Subject: Change of IF Signal Process IC

This service manual supplement is for the ST413E/ 6413TE/DWT1304/ST419E/6419TE changed IC model, which are different from the previous ST413E/ 6413TE/DWT1304/ST419E/6419TE model. For the ST413E/6413TE/DWT1304/ST419E/6419TE changed IC model, an "A" has been added to the end of the model number on rating label in the rear. Refer to the rating label illustration at right.

13" COLOR TELEVISION **DWT1304** ST413E/6413TE

19" COLOR TELEVISION ST419E/6419TE

Main CBA Top View

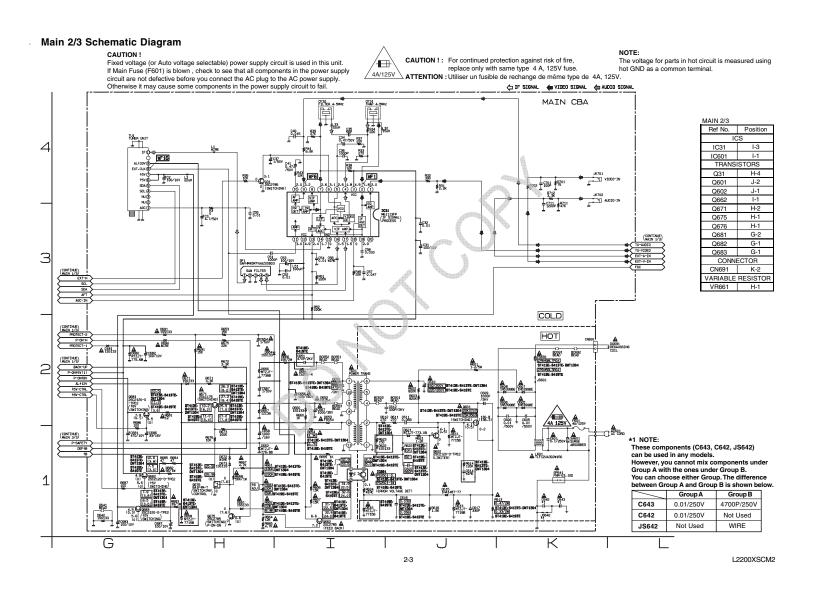
Ref. No.	Description	Part No.	
MECHANICAL	MECHANICAL PARTS		
A4A	RATING LABEL L2200XA		
S6	SERIAL NO. LABEL L2200XA		
ELECTRICAL F	ELECTRICAL PARTS		
	MMA CBA	0ESA05976	
	MAIN CBA		
C38	Not Used		
C609	CERAMIC CAP. B K 1000pF/2KV	CCD3DKD0B102	
IC31	IC:VIF/SIF M61113FP TF0G	QSZBA0SHT035	
R38 ▲	CHIP RES.(1608) 1/10W J 12k Ω	RRXAJB5Z0123	
R132	Not Used
